**From:** [REDACTED]  
**Sent:** 2025-07-29 星期二 18:23:29  
**To:** Shirley Ka Kei CHAN/PLAND <skkchan@pland.gov.hk>  
**Subject:** RE: A/NE-FTA/261 - departmental comments  
**Attachment:** Comments from the TD Department.pdf; DD52 188 D.G.STORE  
HGV SWEPT PATH (TD-01).pdf; DD52 188 D.G.STORE PRIVATE  
CAR SWEPT PATH(TD-02).pdf

**Response to the Comments from the Commissioner for Transport (Contact Person: Mr. TAM Kam-fai, Tel. 2399 2405)**

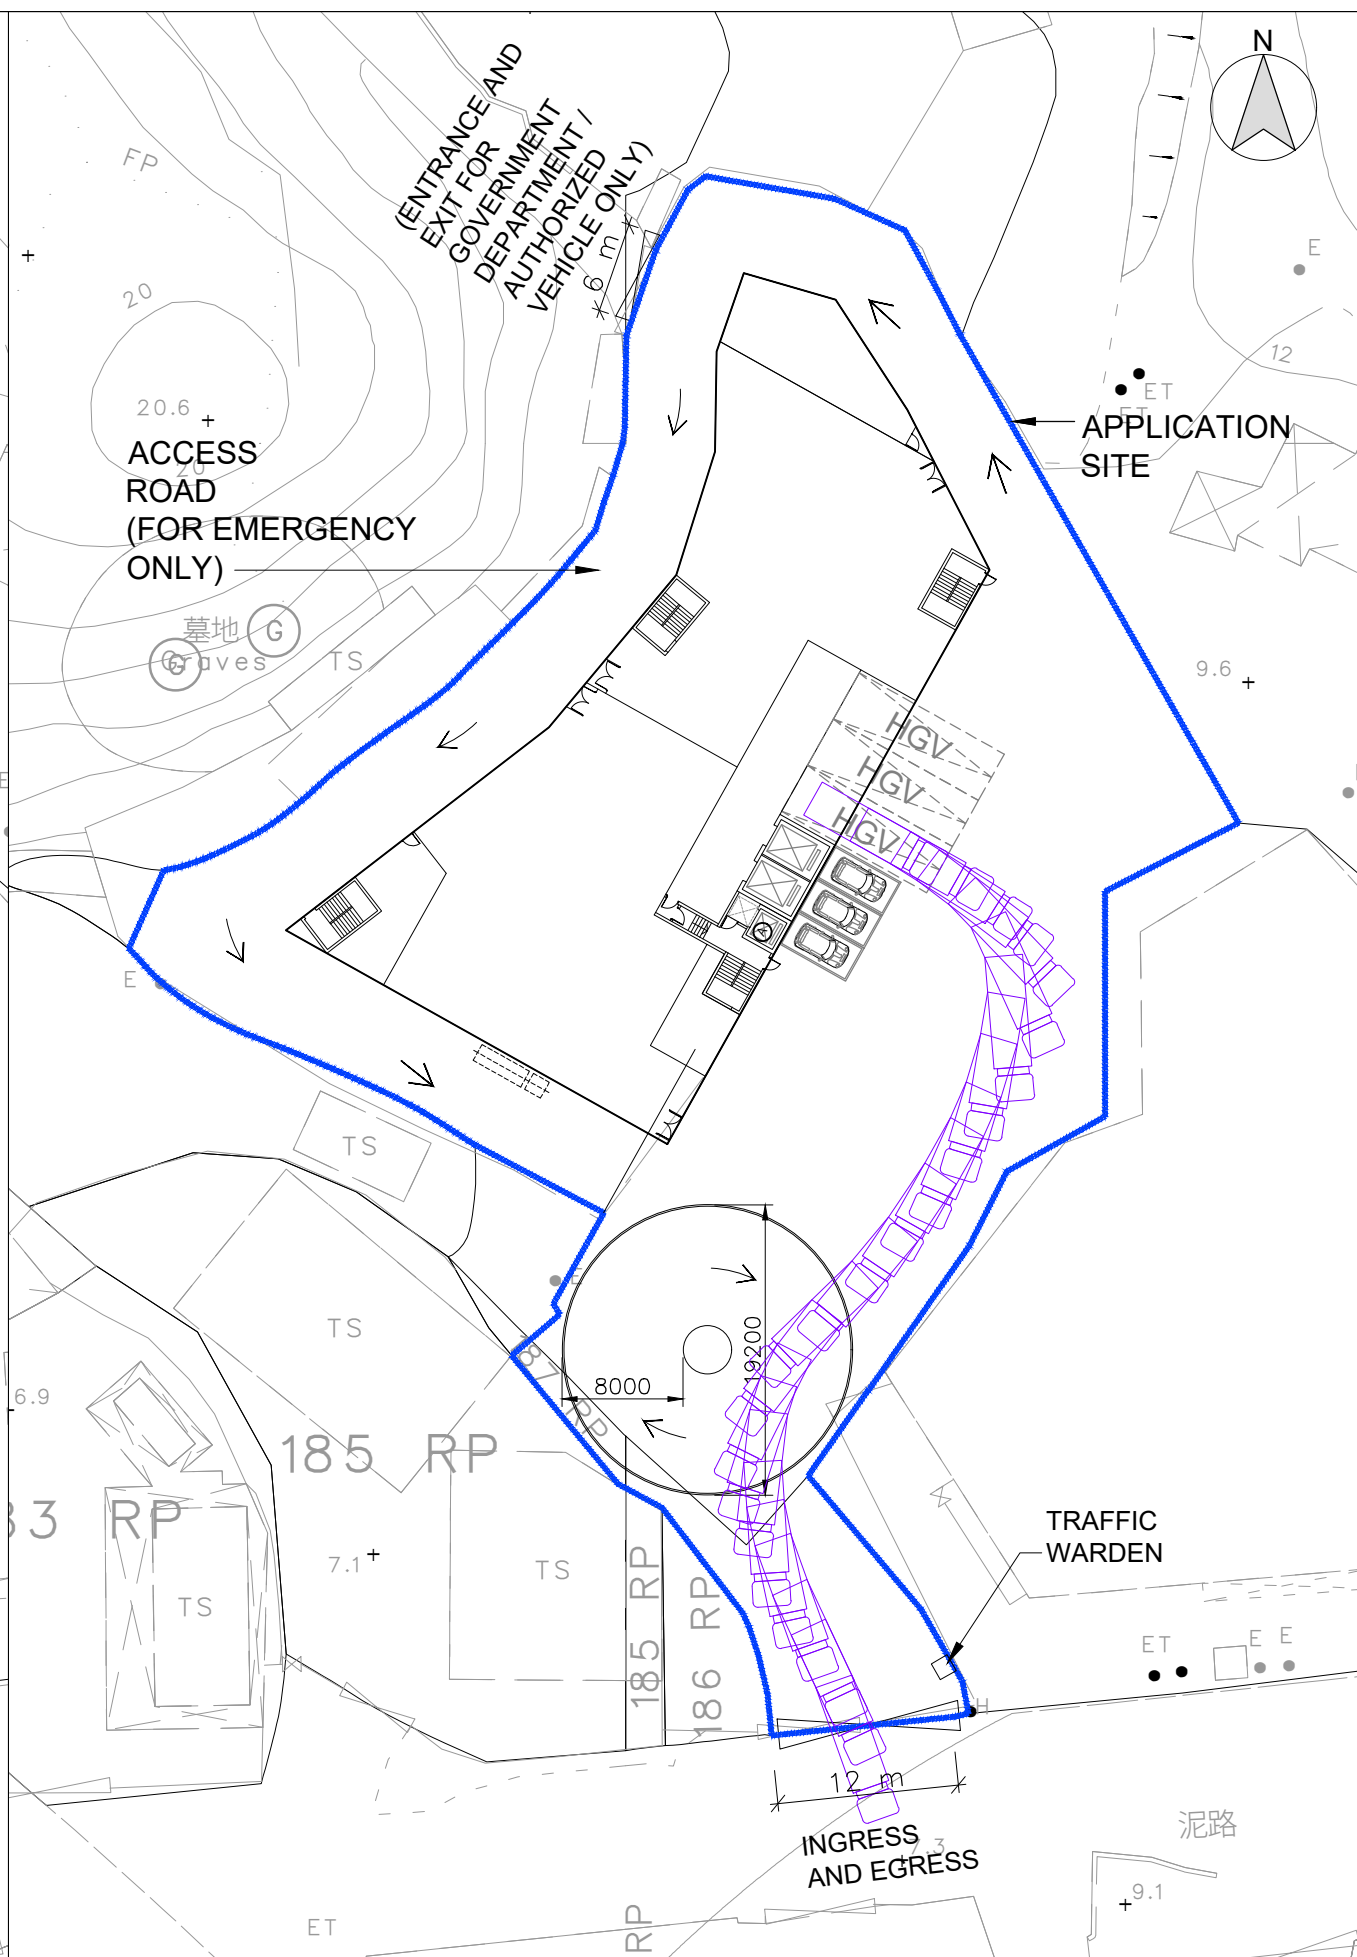
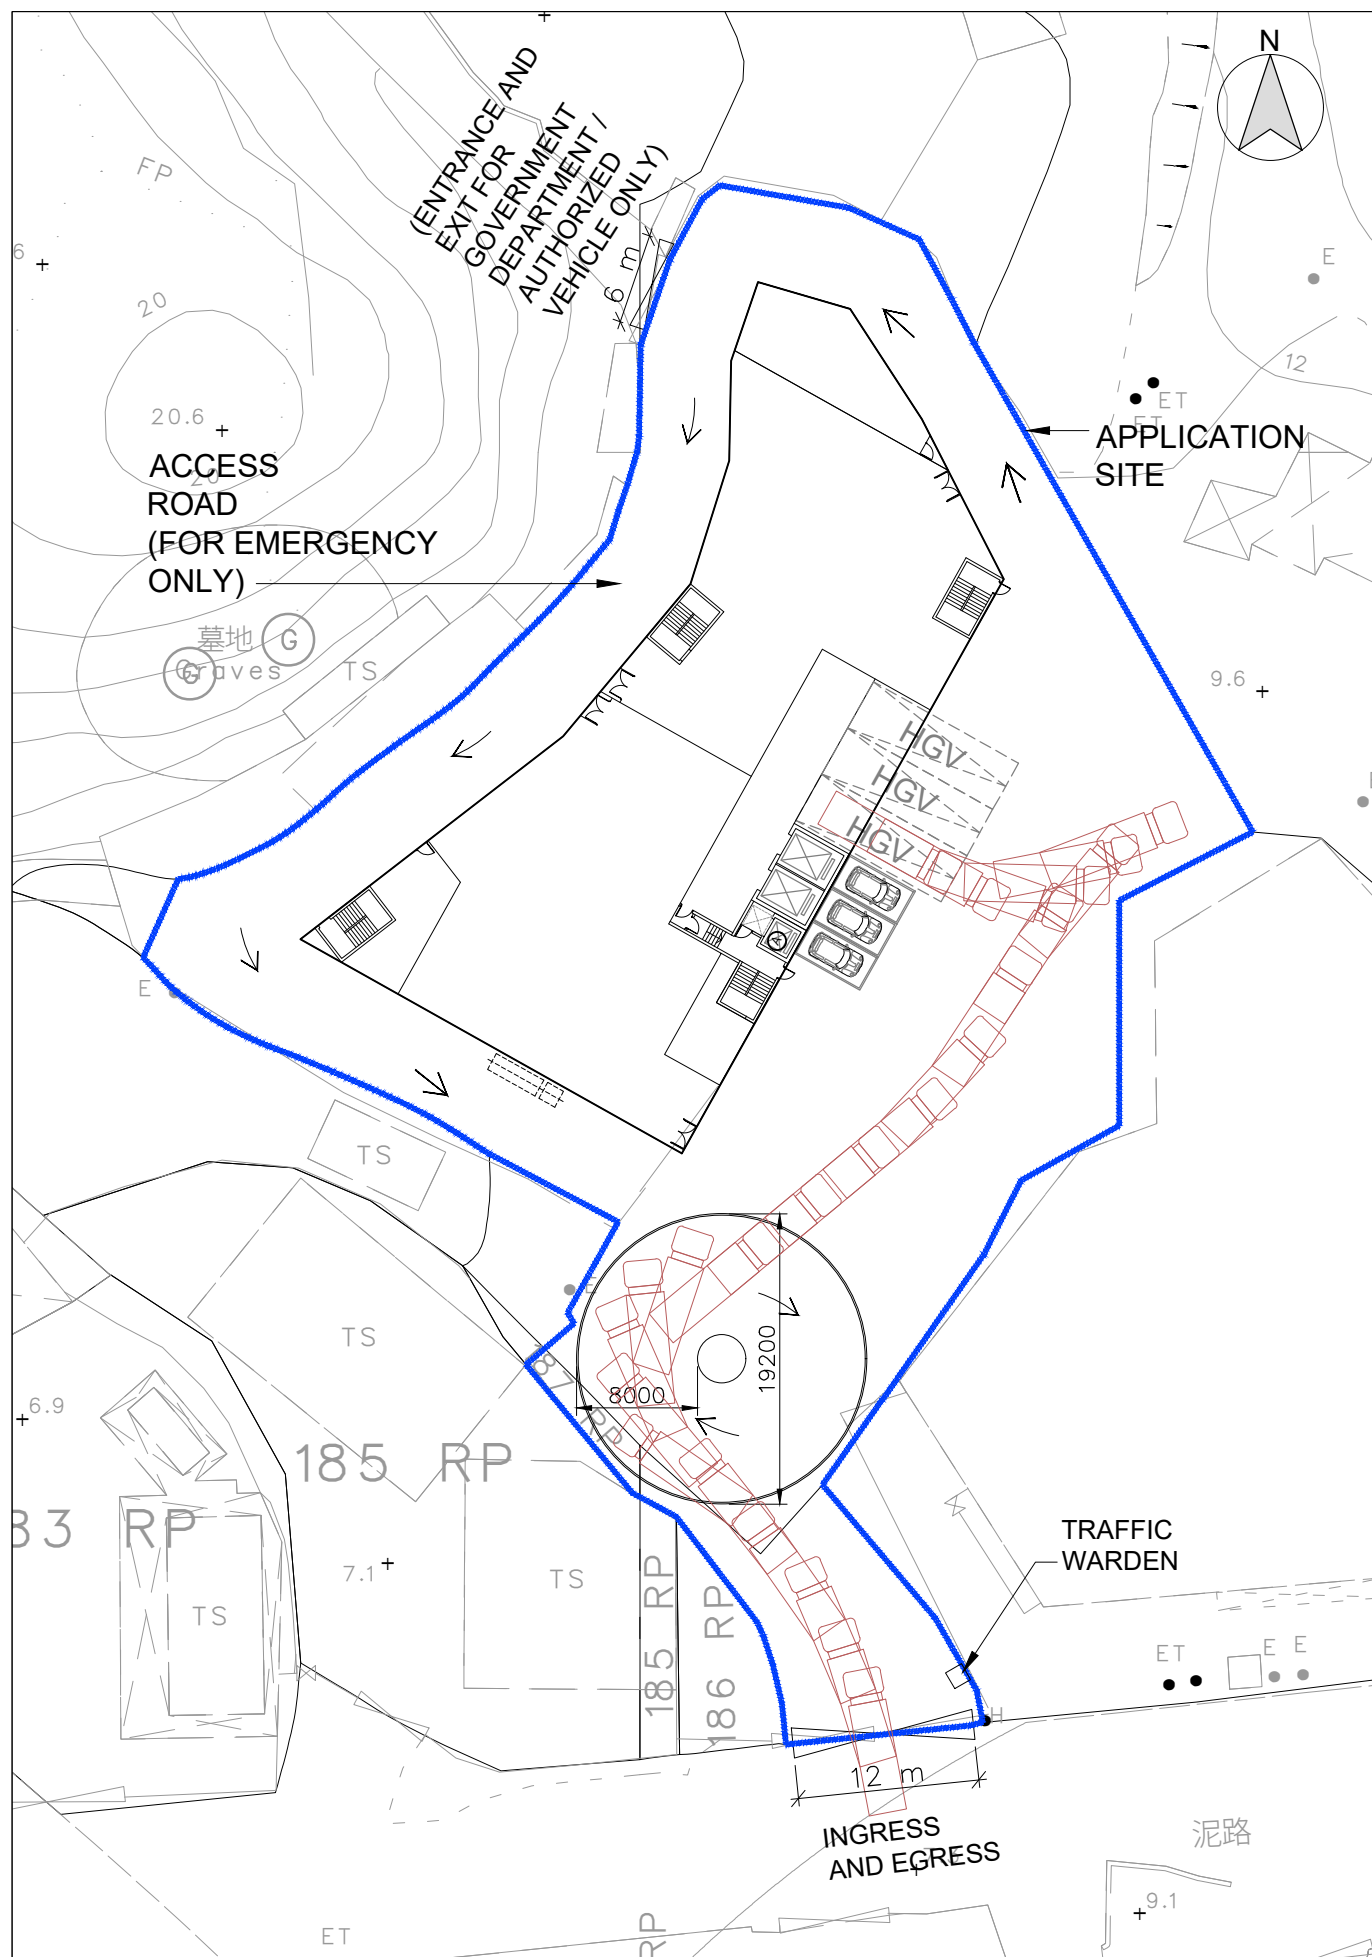
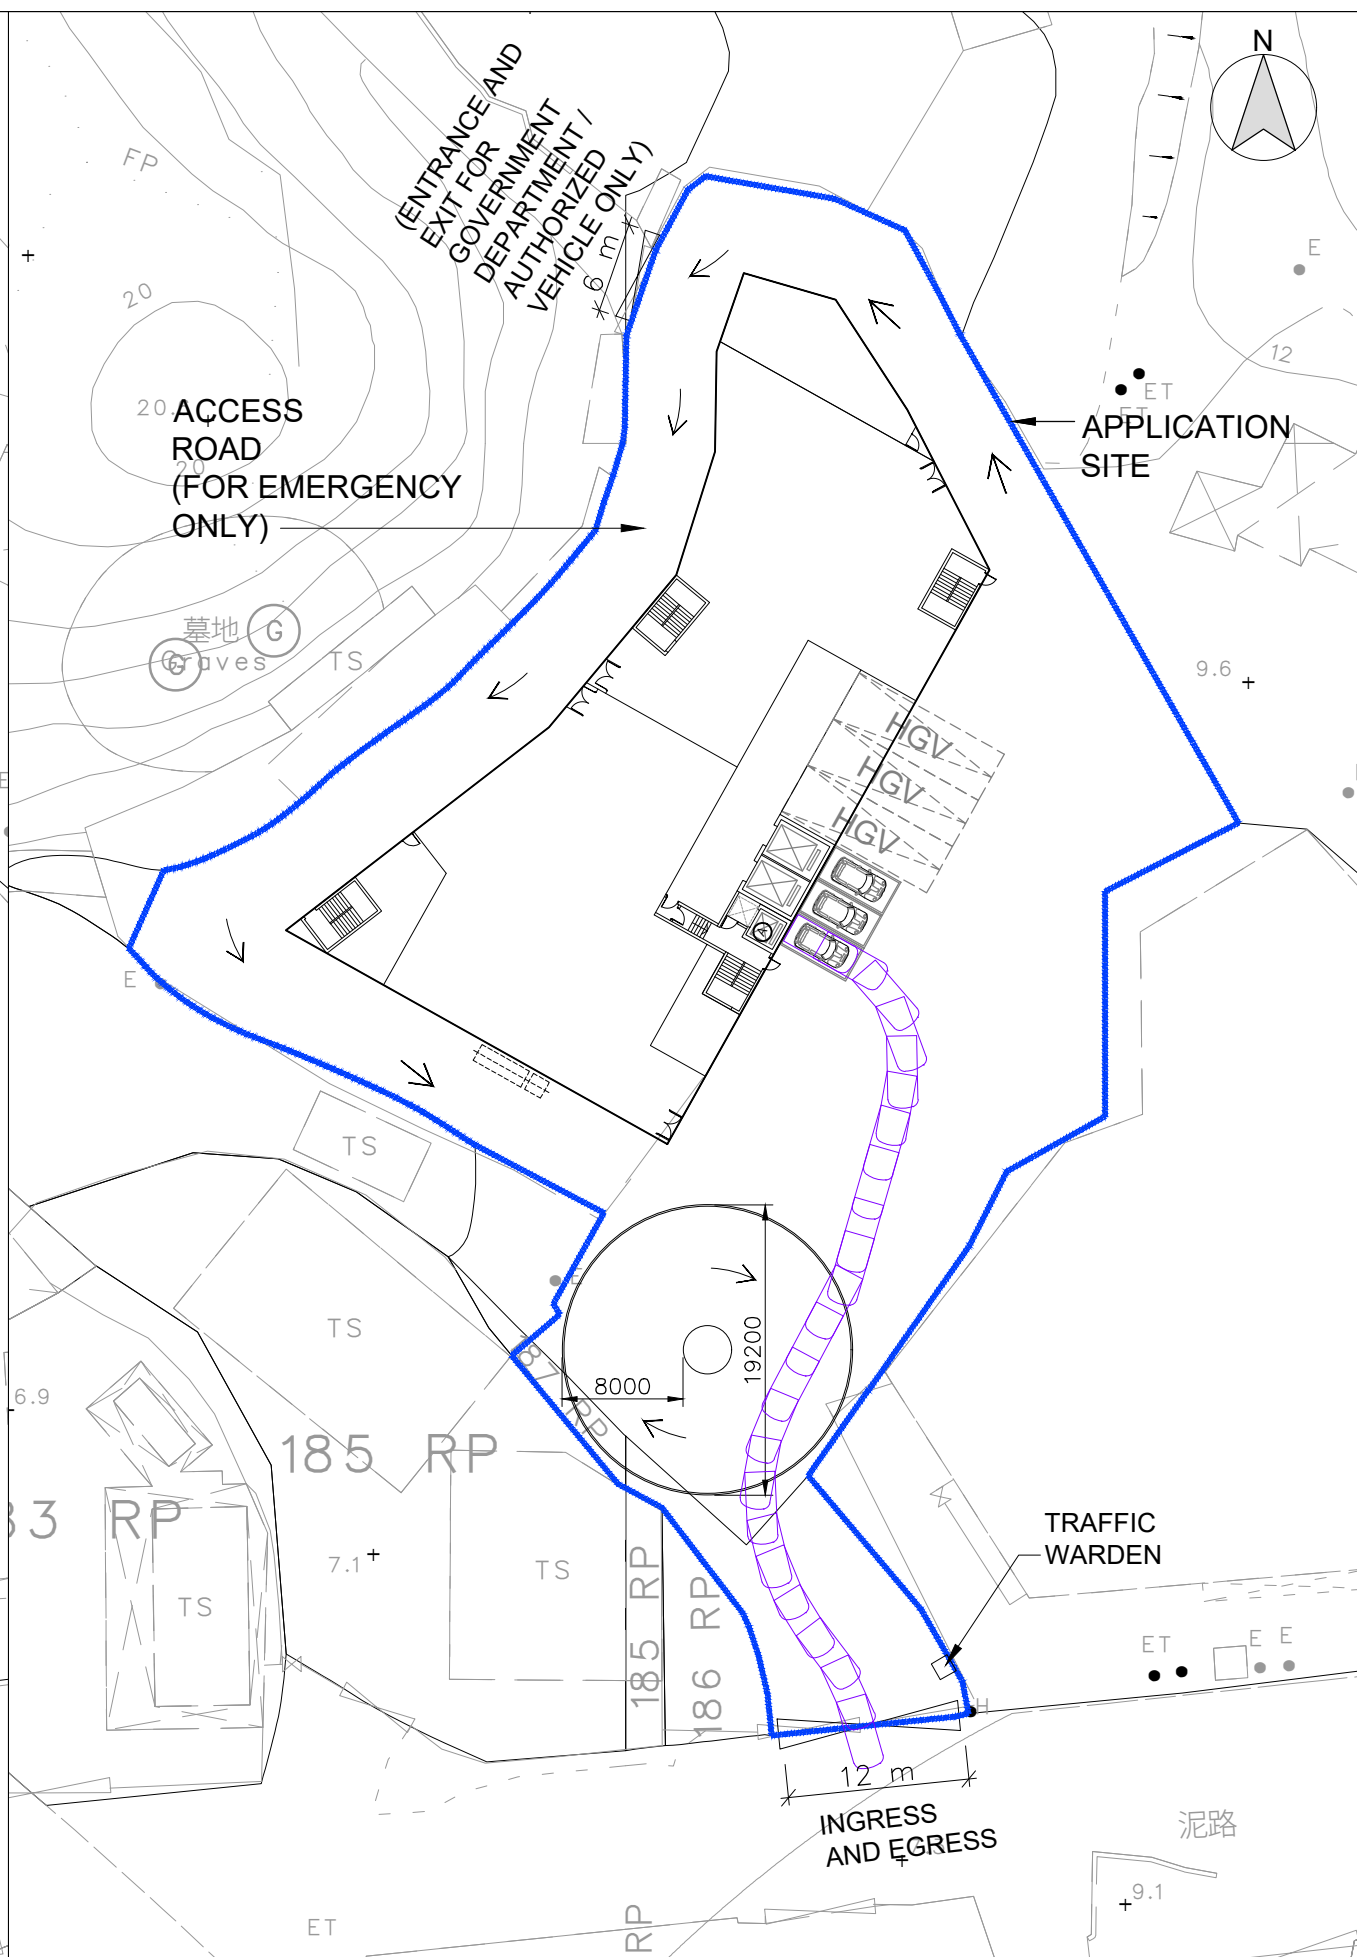
- (i) The applicant should justify the adequacy of the proposed 6m width of the ingress and egress points for vehicular access;  
出入口擴闊至 12 米(請參閱 TD-01 及 TD-02)

- (ii) The applicant shall demonstrate the satisfactory maneuvering of the goods vehicles entering and exiting the subject site, maneuvering within the subject site and into/out of the parking and loading/unloading spaces, preferably using the swept path analysis;  
附上掃掠路徑分析圖(Swept Path Analysis)(請參閱 TD-01 及 TD-02)以顯示貨車足夠進出停放和裝卸空間, 以供參考。
